UNITED STATES
NUCLEAR REGULATORY COMMISSION
WASHINGTON, D.C. 20555-0001

August 1, 2016

SUBJECT: TECHNICAL REVIEW OF QUALITY ASSURANCE
DOCUMENTATION FOR THE CEMENTITIOUS BARRIERS
PARTNERSHIP TOOLBOX (DOCKET NO. PROJ0734)

Technical Review of Quality Assurance Documentation for the Cementitious Barriers Partnership Toolbox

Figure 3. Overview of the CBP Software QA Status

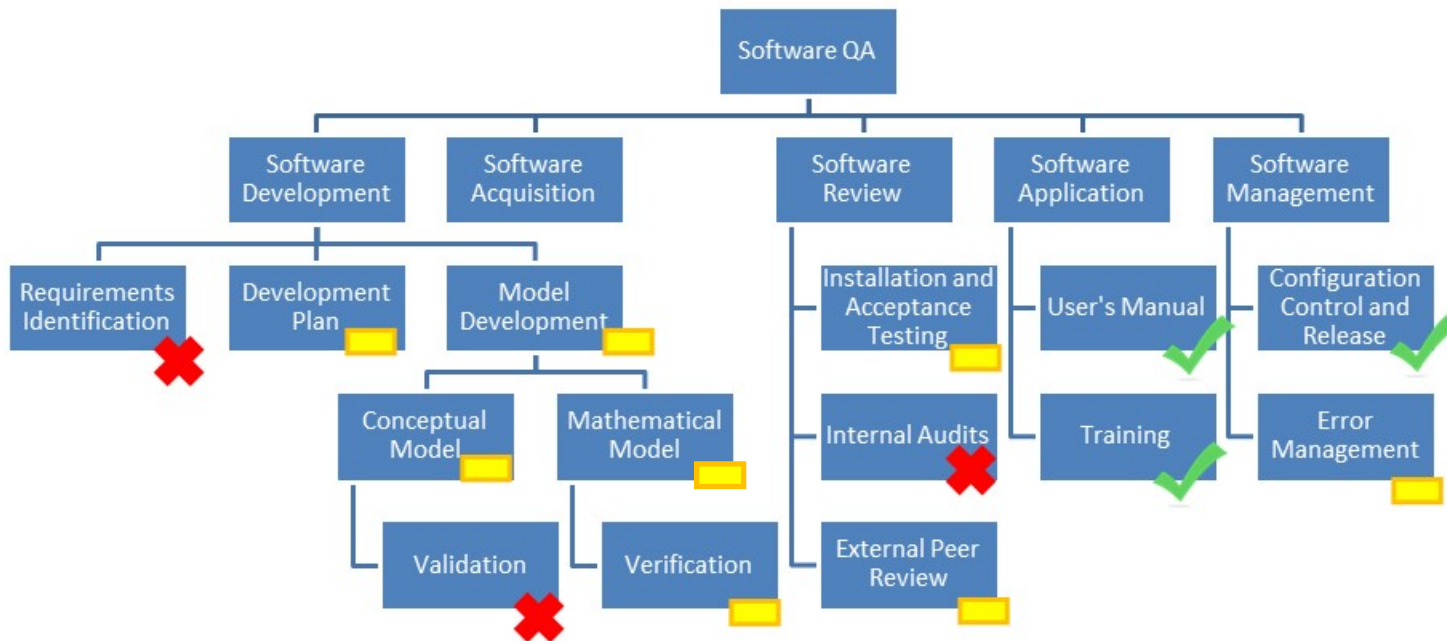
Figure 3 summarizes the NRC's overall summary of the CBP QA program. The green check means essentially completed or generally sufficient, the yellow dash means partially completed or improvement needed, whereas the red X means not completed or insufficient. These high level subjective ratings are essentially an average over all CBP components. For a more in-depth discussion of each individual component, see the sub-sections that follow. Because an NRC staff gave an element a check does not mean that there are not areas of improvement. Likewise because NRC staff gave an element an X does not mean that it is totally deficient.

The NRC staff is trying to present in a clear manner those areas that need the most effort to achieve a level of software QA as recommended in the implementing procedure. Because most of the responsibility for software QA was delegated to the PI's organizations, there is variability from organization to organization.
